Delegated Decision Report

Application No:	25/0972	Statutory Period Expires:	16th June 2026
------------------------	----------------	----------------------------------	----------------------------------

Site:	Stonewell Lower Road Llandevaud Newport South Wales		
Proposal:	PROPOSED ADDITIONAL STOREY INCLUDING NEW HIGHER ROOF AND DORMERS (RESUBMISSION)		
Applicant:	C Williams		
Type:	Full	Ward:	Bishton And Langstone
Decision:	GRANTED WITH CONDITIONS

Figure 2 – Proposed Elevations

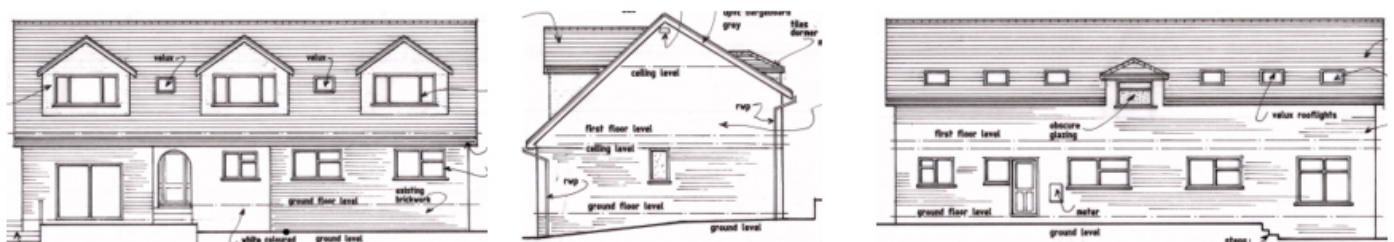
- 3.3 The proposal would result in the increase in height of the building to 7.00 metres, from the original height of 4.20 metres. This would be a reduction of 0.50 metres from the refused application. The design retains an asymmetrical eaves arrangement, with a height of 3.00 metres at the front and 4.17 metres to the rear. This is a reduction in eaves height of circa 0.50 metres due to a change in the roof pitch proposed. The front elevation now contains 3no. pitched roof dormers of matching appearance, size and spacing across the roof plane. The side elevations remain largely blank and will be finished in render at first floor above the existing brick work to the ground floor level. The rear elevation will be constructed of facing brick and the roof design comprises of 1no. hipped roof dormer window and 6no. rooflights.

- The height of the roof and dormer is excessive. The front dormer is significantly higher than the rear, creating an unnecessarily tall and bulky roof profile. This would dominate the property, appear out of scale with neighbouring buildings, and harm the character of this rural area. The overall height would also substantially reduce the sense of openness and rural scene from both Myrtle Cottage and public viewpoints nearby;

8.2.4 The objection from Myrtle Cottage raised concerns regarding the height of the roof and roof dormers, creating an unnecessarily tall and bulky roof profile which would dominate the property, appear out of scale with neighbouring buildings and harm the character of the rural area, as well as substantially reducing the openness and rural scene from Myrtle Cottage and public viewpoints.

8.2.5 The proposed front elevation now contains three pitched roof dormers each of the same design, size and appearance. These dormers are set down from the roof ridge and set back from the eaves so that they appear subservient additions to the roof plane. This provides the front elevation of the dwelling with a much more balanced and coherent appearance in comparison to the refused scheme and is considered acceptable. Front dormers are present on other dormer bungalow style dwellings close-by and are a typical feature. The addition of dormers here will not appear incongruous. The raising of the height of the roof ridge has been reduced compared to the refused scheme, bringing the proposed height down by approximately 550mm. Whilst the raised ridge would still result in asymmetric eaves at the sides, and this was previously considered unacceptable, the height to the rear is also reduced

and the difference is now considered to be far less jarring. The reduction in ridge height and rear eaves height as well as the acceptably designed front dormers are considered to reduce any combined and adverse impact and mitigate key objections to the previous scheme in this respect.

- 8.2.7 The comments on the design and height received from Myrtle Cottage are noted, and have been given due consideration as part of the assessment. However in design terms it is considered that the proposal is now acceptable and would not result in any adverse visual impact on the street scape or the rural character of the surrounding area. As previously referred to, the character within this setting, whilst outside of the settlement boundary, is akin to a village and its very pleasant verdant appearance will not be demonstrably harmed by the proposal. Although it is accepted that views from Myrtle Cottage towards the wider countryside will be impeded to some degree, there is no 'right' to a view and it is not considered that the height increase will result in any demonstrably adverse impact on the neighbouring property that would warrant the refusal of planning permission. Housing design and scale is mixed here, with a mix of older and more recent additions within the locality, as well as extended or modernised properties. The proposed design put forward is not considered to be out of keeping given the overall mix in design, appearance and materials of properties within the vicinity.
